**ALERT SERVICE BULLETIN**

**NO.** 407-01-39

**REV** "A"

**SUBJECT:** BRACKET 407-040-321-101/-103, INSPECTION OF.

**Figure 1. Inspection of the Bracket**

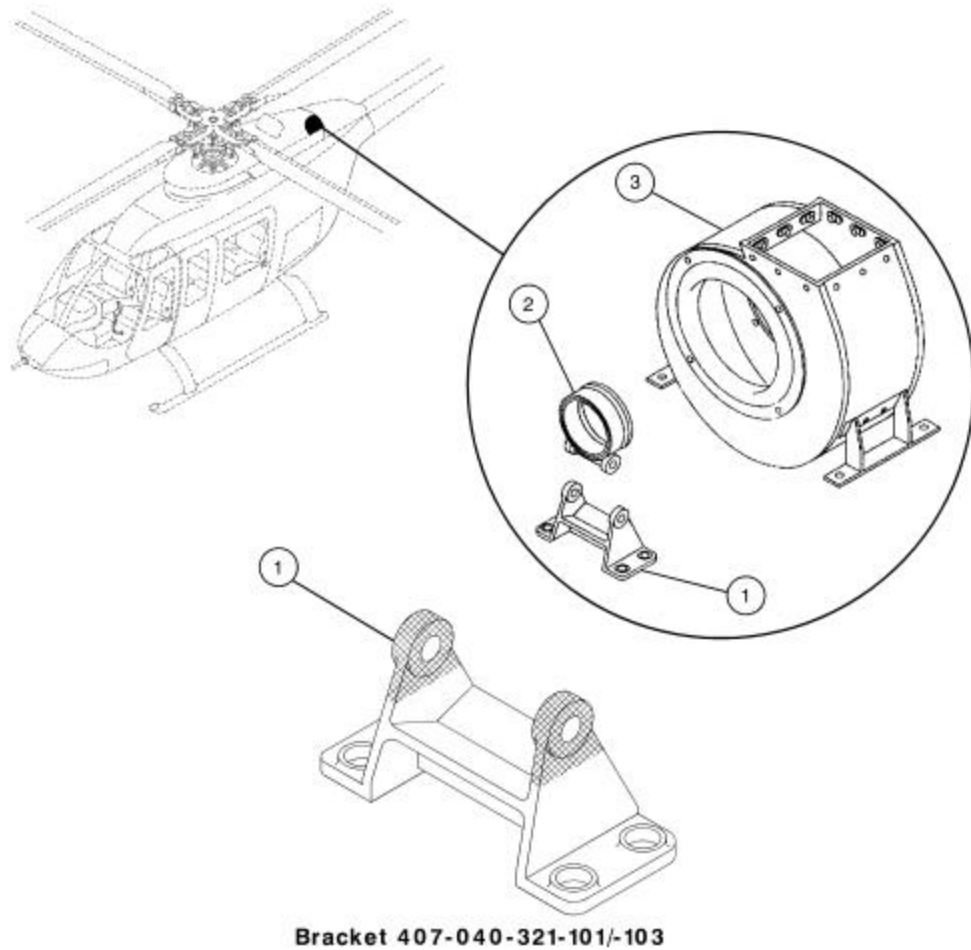
Bell Helicopter has received reports of cracks in the forward bearing hanger support 407-040-321-101. None of the incidents has resulted in the loss of tail rotor drive or tail rotor control.

Pending remedial action for affected ship, this Alert Service Bulletin is released to introduce a recurring 25 hour inspection to check the forward hanger support for cracks.

1. Do this inspection within 25 hours after receiving this bulletin and each 25 hours of operation thereafter.
2. Remove the cowling to get access to the bracket (1, Figure 1).

You do not need to remove the bracket to do the inspection. A visual inspection of the bracket exposed area to be inspected is acceptable. If for any reason the bearing hanger is removed, a complete visual inspection of the area to be inspected is required.

3. Use a mirror and visually inspect the bracket (1) for cracks in the areas shown in Figure 1.
4. If no crack is detected, return the aircraft to service.
5. If a crack is detected, replace the affected support. Notify Bell Helicopter Product Support Engineering that you have detected a cracked support.

- 1. Do a visual inspection of the exposed surface of the shaded area. Dismantling of bearing hanger and the support is not required.
